Bulletin No: 99 SW1 REV
Release Date: 07/02/99
Effective Date: 07/02/99
Supersedes: 99 SW1
Completion Date: As soon as possible
Page: 1 of 2

SERVICE BULLETIN

Ride Manufacturer: Zamperla Inc.	Affected Production Dates: All
Ride Name: Speedway	Affected Serial Nos.: All
Model Number: Speedway

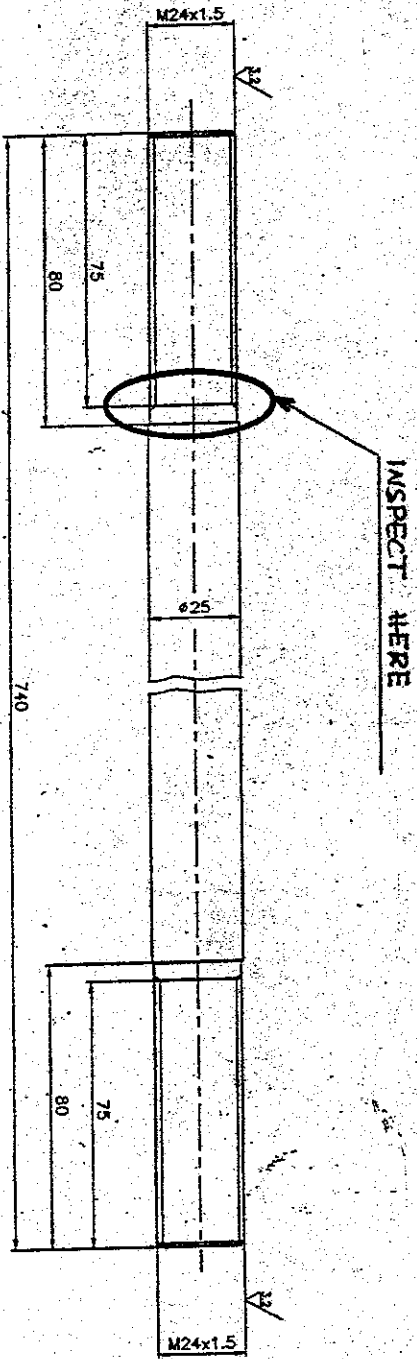
Abstract Of Issue:
Cracks have been found in the bars that support the spring and connect the car to the chain. Specifically, the area where the threading on the shaft stops. See area indicated on the accompanying diagram.

Detail Of Issue:
If cracks have been detected in the above mentioned areas and confirmed, please stop the ride and immediately contact Zamperla.

Action To Be Taken:
Close visual control and dye penetrant testing by a certified NDT technician. (Rides that are new for the 1999 season may delay testing until next operating season.)

Future Action To Be Taken:
Close visual inspection and dye penetrant testing by a certified NDT technician annually.
